RE: Docket No. 22-53-EL - Rhode Island Energy's Proposed FY 2024 Electric Infrastructure, Safety, and Reliability Plan Responses to Data Requests – PUC Set 1

In Re: Proposed FY 2024 Electric Infrastructure, Safety and Reliability Plan
21-Month Filing: Period April 2023 – December 2024
Responses to the Commission’s First Set of Data Requests
Issued on January 19, 2023

Figure 6.22: Communication System with Fiber Backhaul

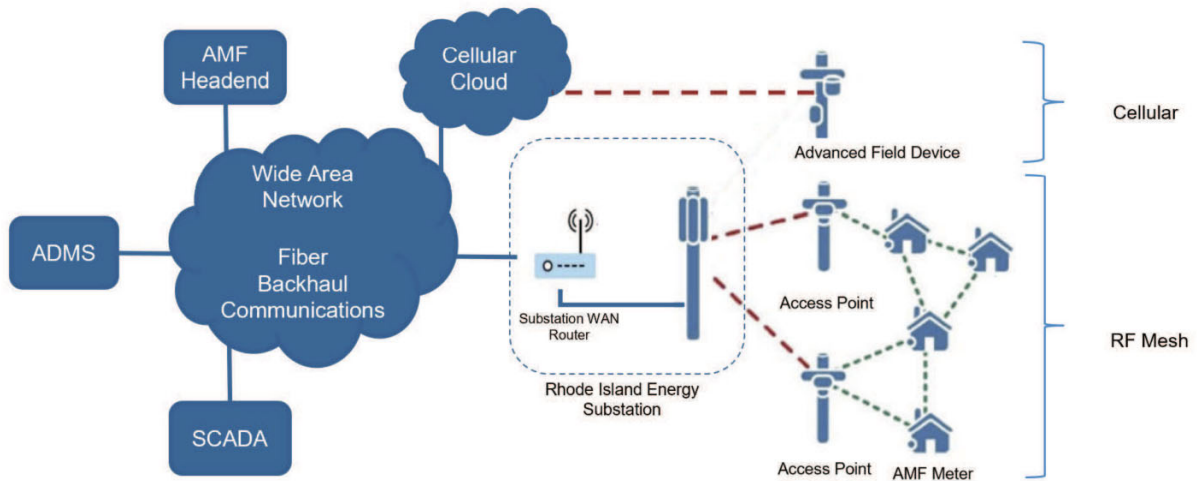
- (a) Please provide a comprehensive explanation regarding the proposed fiber investments that distinguishes between (i) fiber that is installed to upgrade communications to and from substations from (ii) the scope of fiber installations that would be needed to provide back-hauling communications from the AMF meters at customer premises, including geographical scope and cost.
- (b) Is it feasible for the fiber deployment to be limited to substation communications? If so, would there be a material reduction in the five-year budget? What would the effect be on the Company's plans and operational expectations?

- (a) The fiber investment that is being proposed as part of the Foundational Investments is to and from substations to the Headend as described in Section 6.5 of the GMP primarily for the purpose of providing real-time operational needs. The fiber infrastructure could be used to backhaul AMF data where applicable and feasible at substation take-off points in addition to being available for SCADA and system protection. The fiber is not being proposed to the customer premise. Communications for AMF to and from customers' premises will be a private RF mesh communication system that is included in the AMF proposal. A diagram illustrating the various communication components was included in the GMP, Figure 6.22 and provided below. Please also see the Company's responses to PUC 1-27 and PUC 1-28 for additional information.

- (b) Yes. Limiting the fiber deployment to substation communications is certainly feasible and it is what the Company has proposed in the Foundational Investments of the GMP and in the ISR investments. There is no funding for fiber deployment in the five-year plan beyond substation communications and as such, there would be no effect on the Company’s plans and operational expectations.
